UNITED STATES PATENT AND TRADEMARK OFFICE

APPLICATION NO.	FILING DATE	FIRST NAMED INVENTOR	ATTORNEY DOCKET NO.	CONFIRMATION NO.
10/797,489	03/10/2004	Mark A. Turner	2063.007800	3998

Office Action Summary	Application No.	Applicant(s)	
	10/797,489	TURNER, MARK A.	
	Examiner	Art Unit	
	David D. Le	3681

DETAILED ACTION

FIG. 1

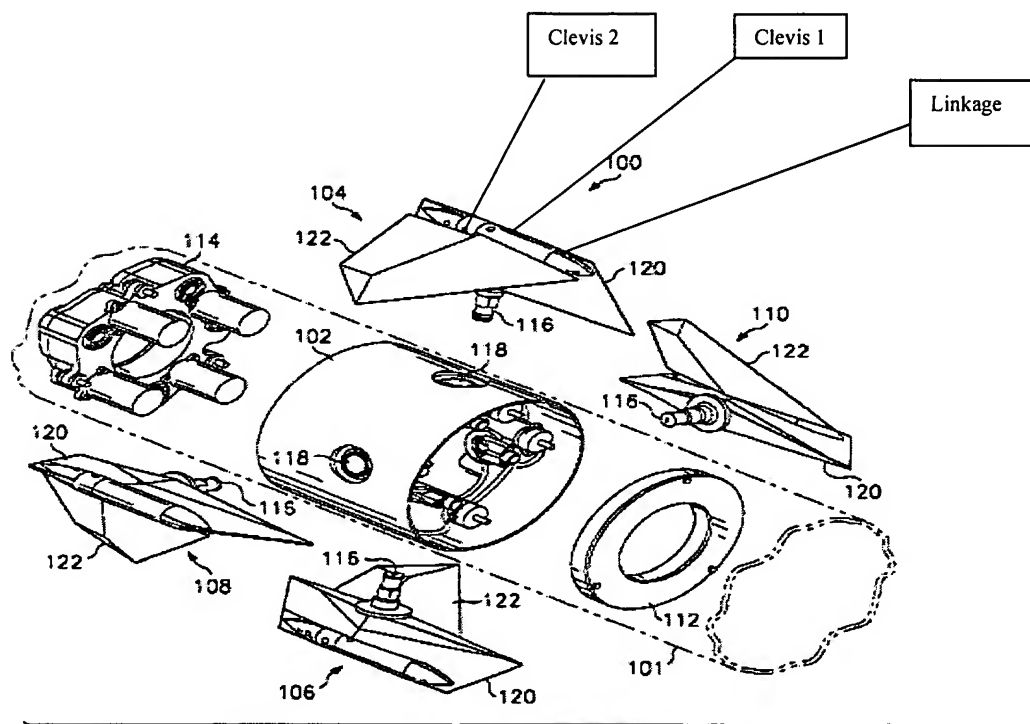
- A translation nut (i.e., Fig. 6, element 508) having a clevis (being the Clevis 1 in Fig. 1 below);

- A linkage (being the Linkage in Fig. 1 below) mechanically coupled with the clevis and capable of being coupled with a clevis (being the Clevis 2 in the Fig. 1 below) of a control surface shaft;

- An actuation controller (i.e., Fig. 1, element 112) coupled with the drive assemblies, such that actuation commands may be transmitted from the actuation controller to the drive assemblies;
- Wherein the controlling apparatus (100) mechanically combines either roll and pitch inputs (i.e., Fig. 3, element 330) or roll and yaw inputs (i.e., Fig. 3, element 326) into a single mechanical output to the control surface.
